Prairie Island Independent Spent Fuel Storage Installation
Docket 72-10
Renewed Materials License No. SNM-2506

Response to Request for Additional Information: License Amendment Request to Expand the Storage Capacity of the Independent Spent Fuel Storage Installation (ISFSI) (EPID No. L-2019-LLA-0169)

Response to Request for Additional Information

License Amendment Request to Expand the Storage Capacity of the Independent Spent Fuel Storage Installation (ISFSI)

Figure 2.1: Soil Liquefaction Factor of Safety from CPT and SPT data

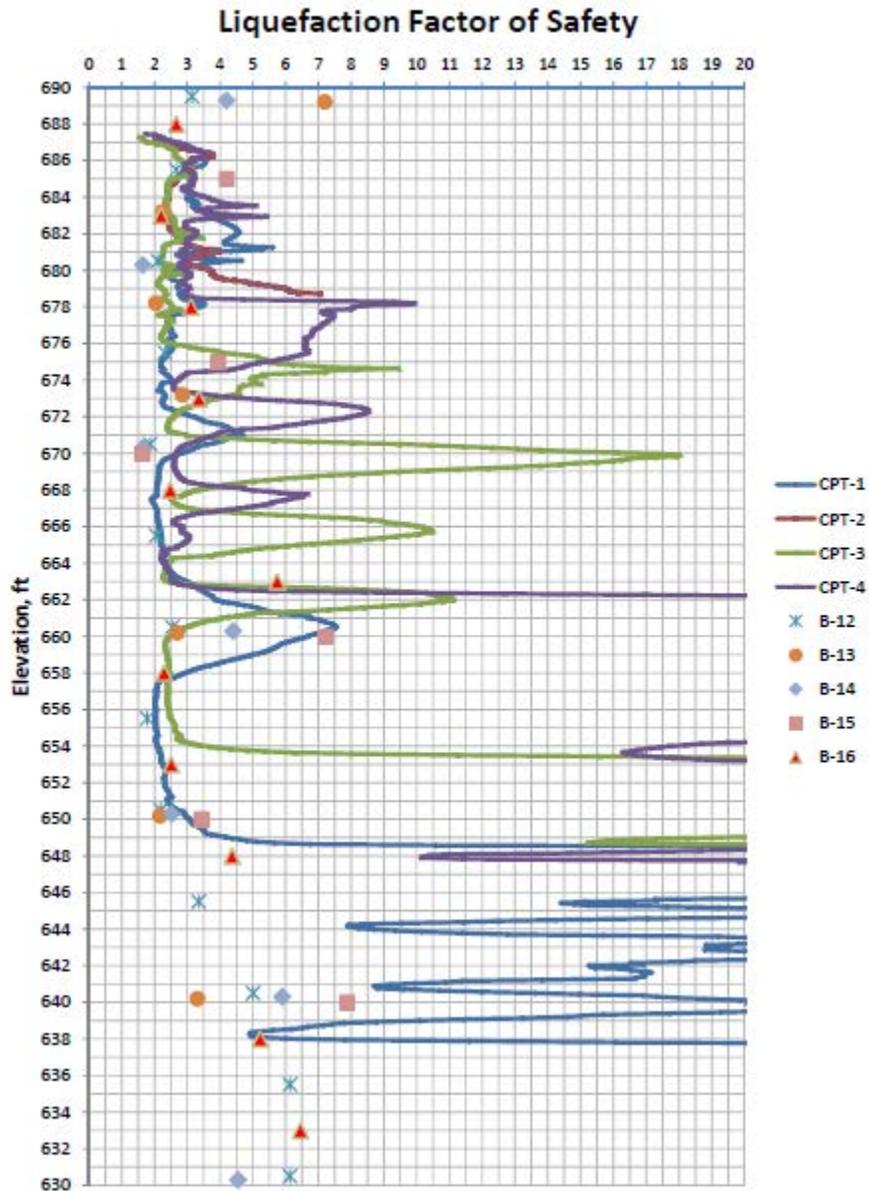
- c. Provide the values of Cyclic Resistance Ratio (CRR) and Cyclic Stress Ratio (CSR) and/or Factors of Safety (FS) in graphical or tabular form for the depths of study as related to the proposed ISFSI pad. Also provide a calculation package or sample calculations describing the efforts made for this analysis. In Section 3.2.2 of the submittal, the applicant states “the ratio of the shear resistance (CRR) of the soil under repetitive loading to earthquake-induced shear stresses (CSR) at various depths was calculated using both the CPT and SPT data.” The staff cannot determine how the current CPT and SPT data correlate.

For numerical analysis of the soil liquefaction potential of the new ISFSI pad site, detailed calculations were performed for the site. A numerical analysis establishes the factor of safety ($FS = CRR/CSR$) against liquefaction for the sites. The ratio of the shear resistance (CRR) of the soil under repetitive loading to earthquake-induced shear stresses (CSR) at various depths is calculated using both CPT and SPT data. Calculation of CRR and CSR, and the liquefaction

evaluation using the resulting FS, follows the procedures described in Regulatory Guide (RG) 1.198, "Procedures and Criteria for Assessing Seismic Soil Liquefaction at Nuclear Power Plant Sites" (Reference 3), and NUREG/CR-5741, "Technical Bases for Regulatory Guide for Soil Liquefaction" (Reference 4). A detailed calculation was performed following a procedure by Youd, T.L., Idriss, I.M., et al. (Reference 5), which is referenced by RG 1.198.

Figure 2.1 provides FS values at various depths of the site for both CPT and SPT data.

Figure 2.2: Artificial (Synthetic) Acceleration Time-History, Horizontal H1

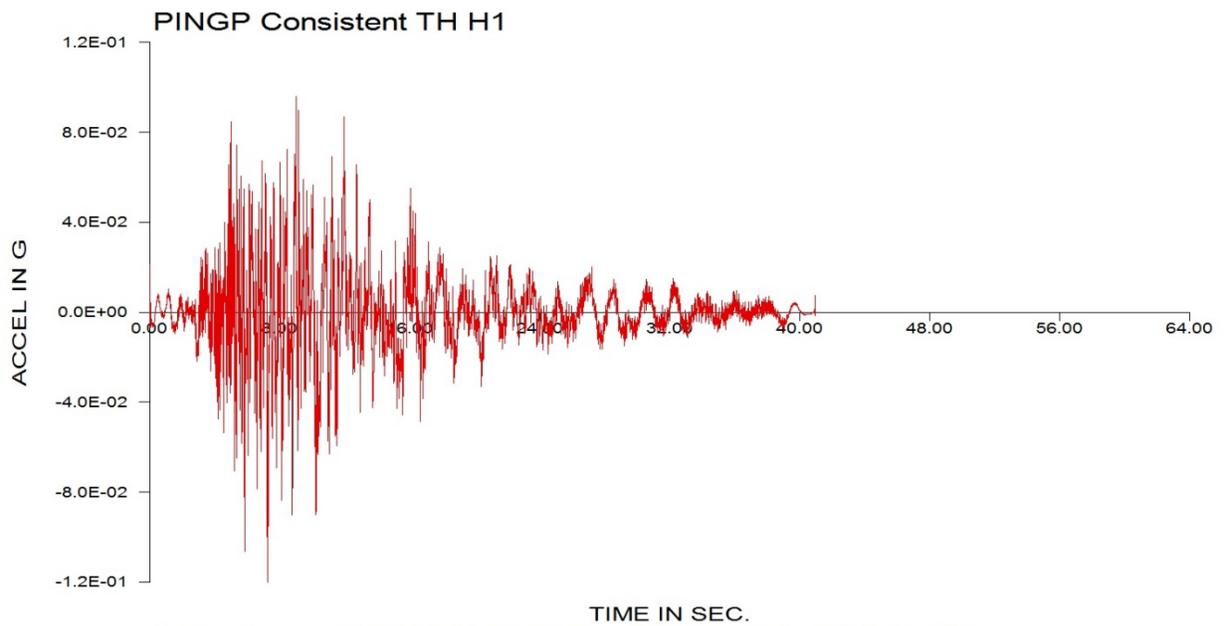
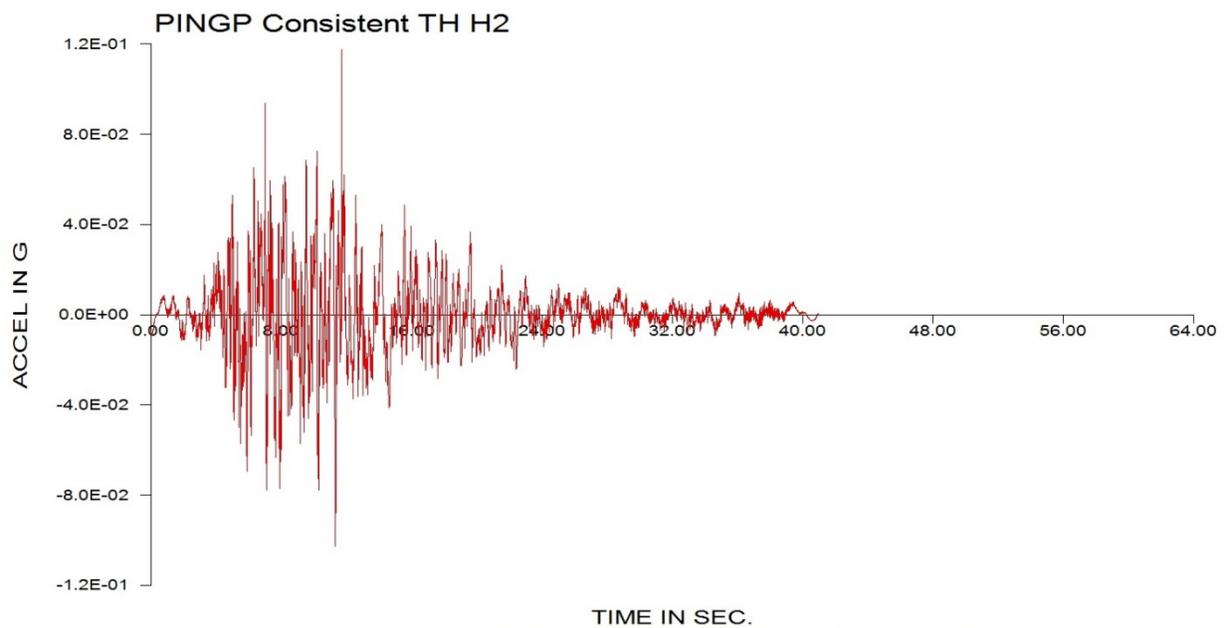
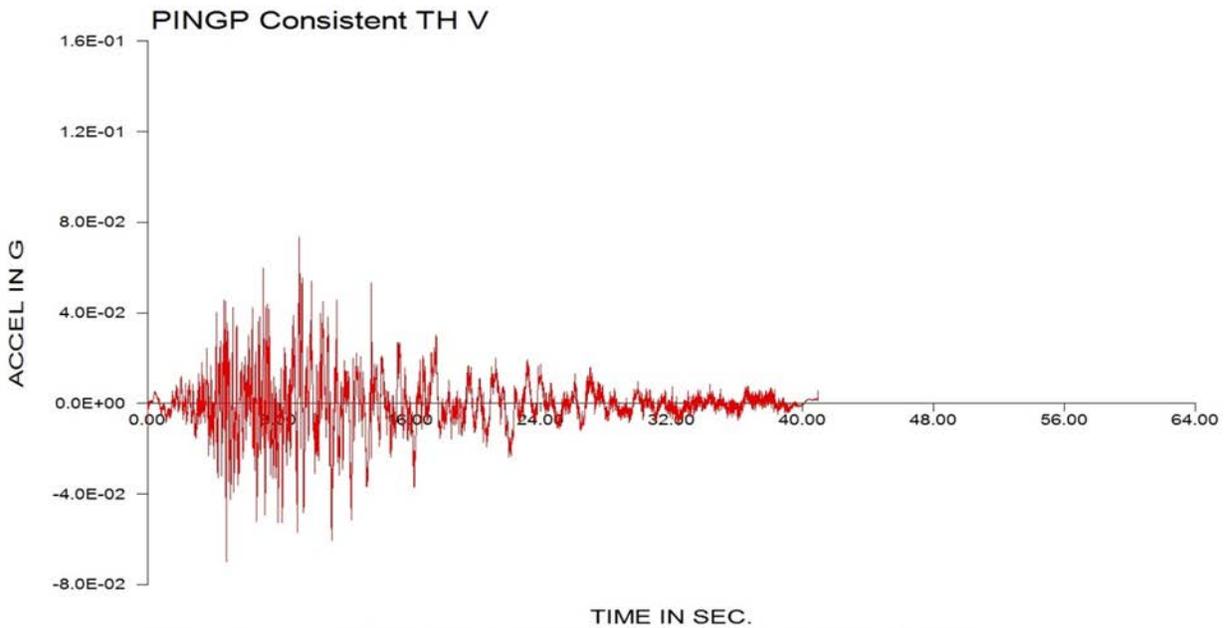
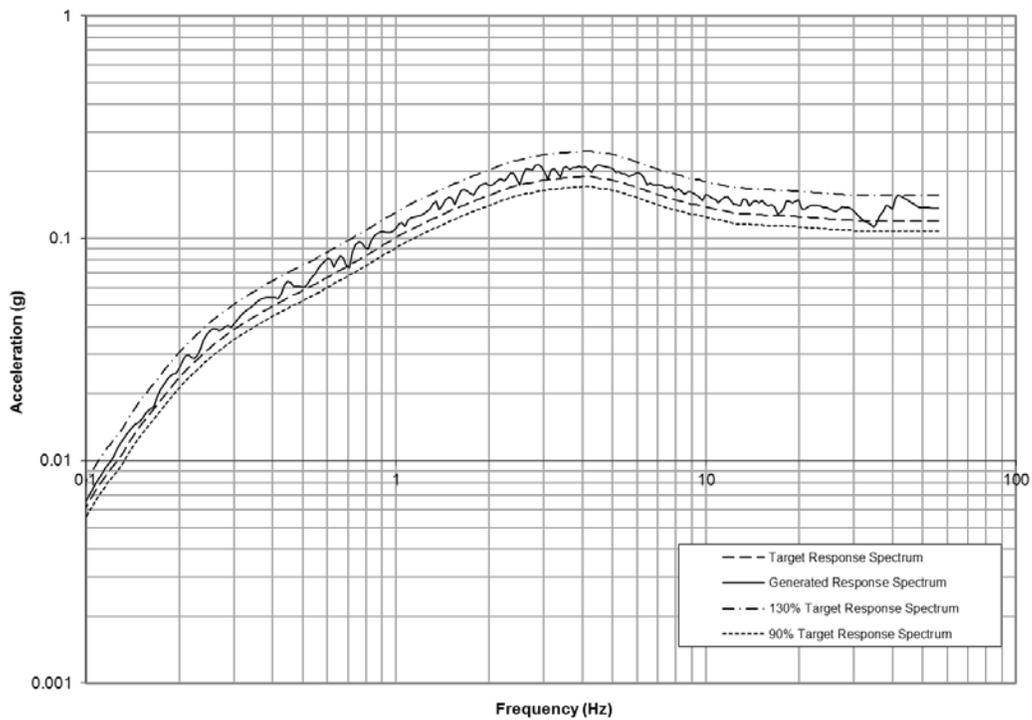
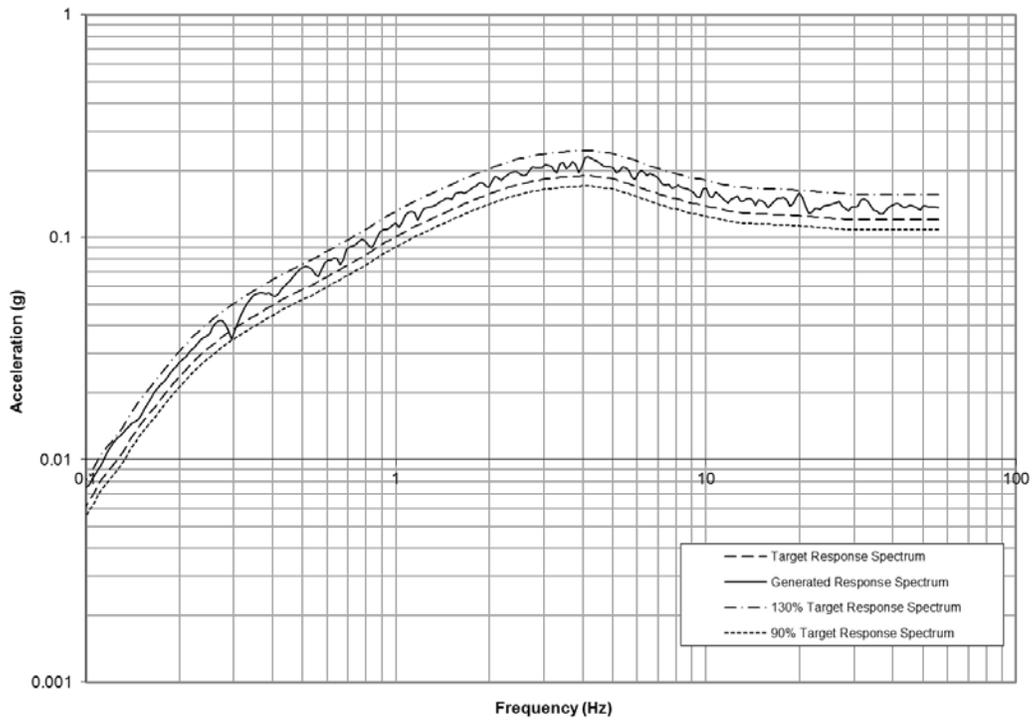
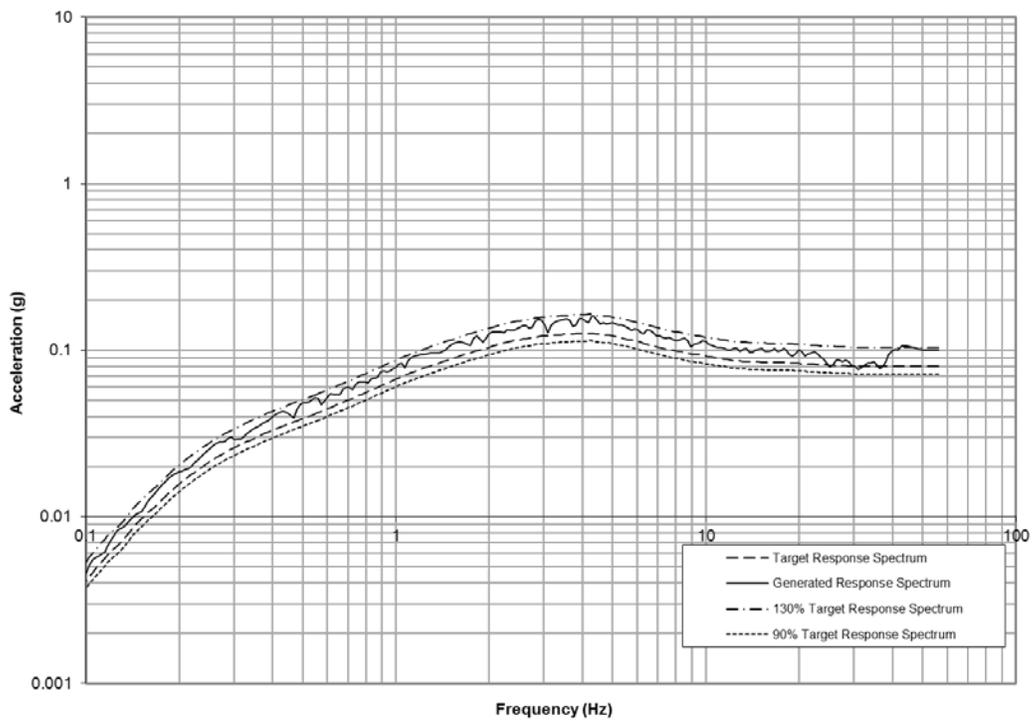
- a. Provide the Acceleration Input Motions generated per Approach 2, Option 1 of NUREG 0800, Chapter 3.7.1.
- b. Provide the Upper Bound, Best estimate and Lower Bound strain compatible soil properties (shear modulus and damping) data per depth generated for the SSI analysis in graphical or tabular form.
- c. Justify why Model 3 for the single cask on the corner of the pad is the governing loading case.
- d. Provide a schematic of the ISFSI pad model used for SASSI2010 analysis including mesh distribution and sizes.
- e. Provide results of the 36 SSI analysis cases analyzed in tabular format, as appropriate.

To perform soil-structure interaction analysis, artificial acceleration input motions that are consistent with the design input response spectra were developed following NUREG-0800, Chapter 3.7.1. The generated acceleration input motions are shown in Figures 2.2 through Figures 2.4 and acceleration response spectra comparisons are shown in Figures 2.5 through 2.7. The generated acceleration input motions also meet the requirements for the strong motion duration, the absolute values of correlation coefficient, the energy gap for the frequency range of interests, and the phase angle consistency.

Figure 2.14: Finite Element Analysis Mesh

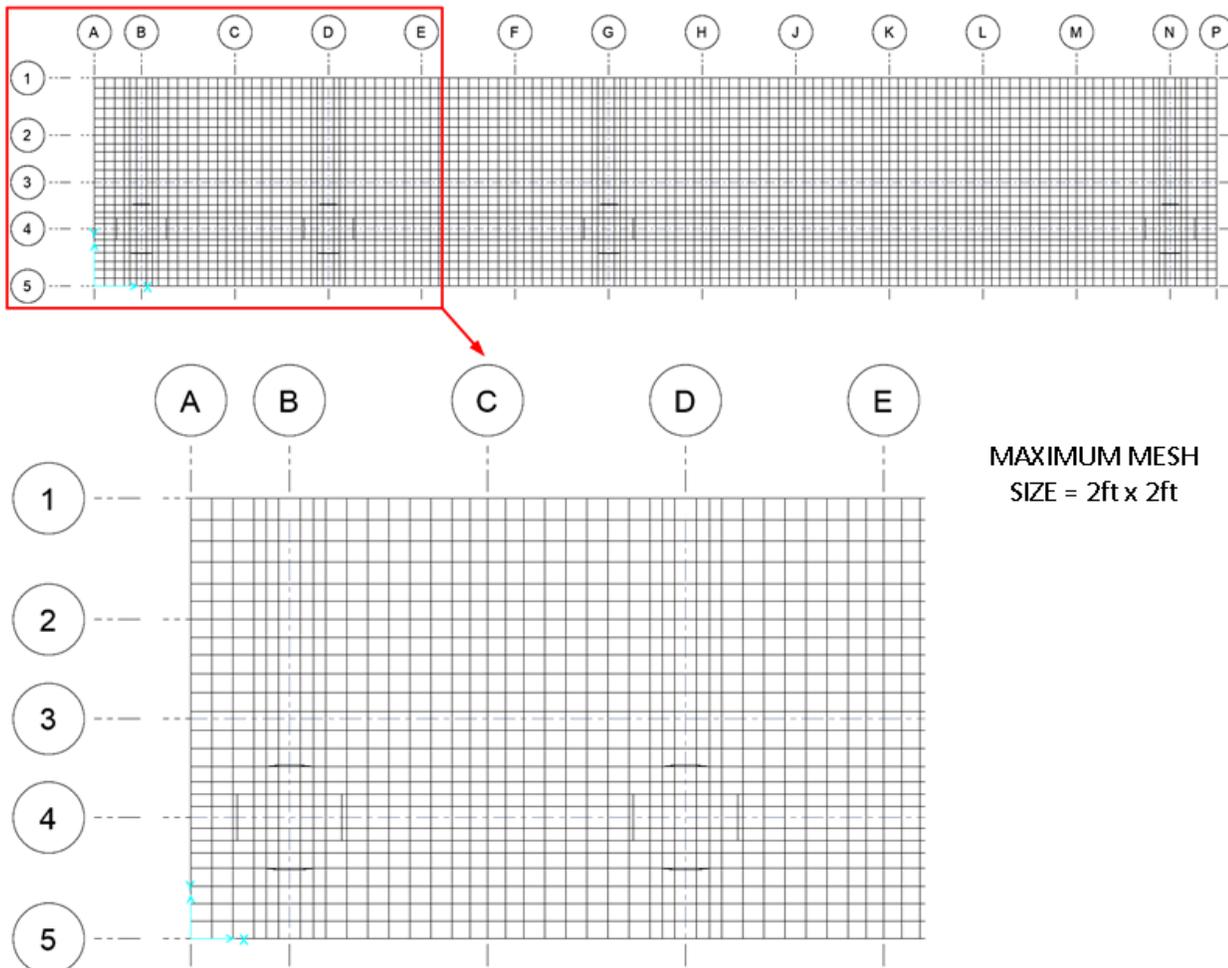
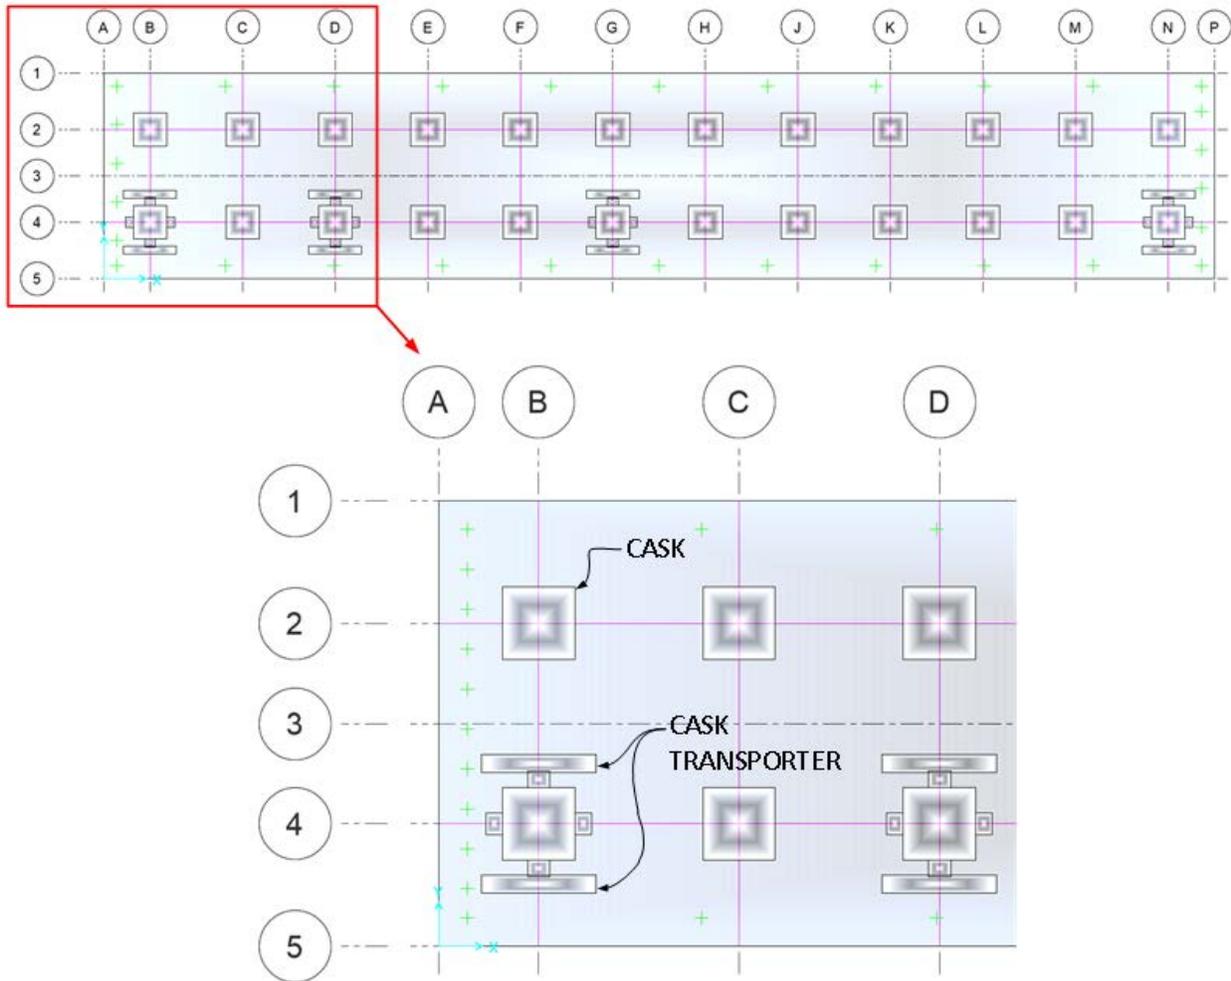
- a. Details on calculation of subgrade modulus for the SAFE analysis.
- b. Pad settlement and differential settlement evaluations
- c. Schematic of finite element mesh generated by SAFE for ISFSI pad.
- d. Results of load combination permutations used in SAFE design models as stated in the last paragraph of Section of 3.4.2.2.
- e. Final pad reinforcement details resulting from shear and flexure design for the various cask load configurations and combinations.
- f. Results of maximum soil bearing pressure evaluation

The finite element mesh and cask locations on the pad are provided Figures 2.14 and 2.15.
